Economic and Social Council

Amendments to the Police Regulations for the Navigation of the Mosel

Decisions of the plenary session of the Mosel Commission, held on 1 June 2022 in Senningen (Luxembourg) (CM-I-22)

Item 5.2. Amendment of the Police Regulations for the Navigation of the Mosel (RPNM) to harmonize RPNM with the Police Regulations for the Navigation of the Rhine (RPNR)

Indications concerning the W, L, A, B, C and D values of a vessel

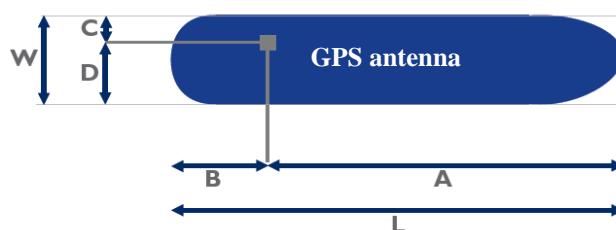
4. RPNM annex 11, paragraph (2), reads as follows:

“2. Information acquisition point relative to the position on board the vessel

2.1 If the Inland AIS device was installed on board before 1 December 2015:

- (a) For a vessel

The skipper must enter the values A, B, C and D with an accuracy of 1 m.
Dimension A is oriented towards the bow.

Indications concerning the W, L, A, B, C and D values of a convoy

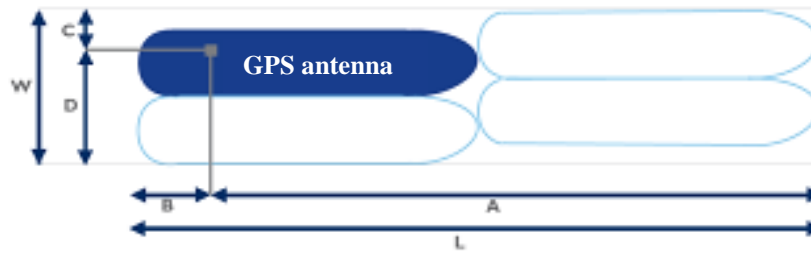
- (b) For a convoy

The skipper must enter the values A, B, C and D with an accuracy of 1 m and the values W and L with an accuracy of 0.1 m.

Dimension A is oriented towards the bow.

Indications concerning the W, L, A, B, C and D values of a vessel

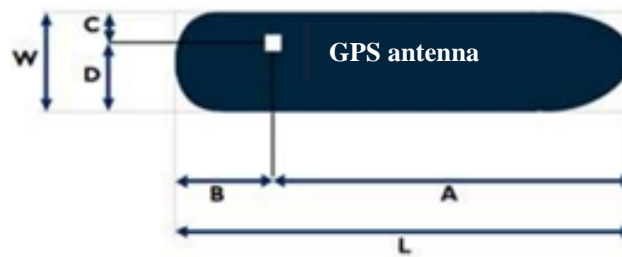
2.2 If the Inland AIS device was installed on board after 1 December 2015:

(a) For a vessel

The skipper must enter the A, B, C and D values with an accuracy of 0.1 m.

Dimension A is oriented towards the bow.
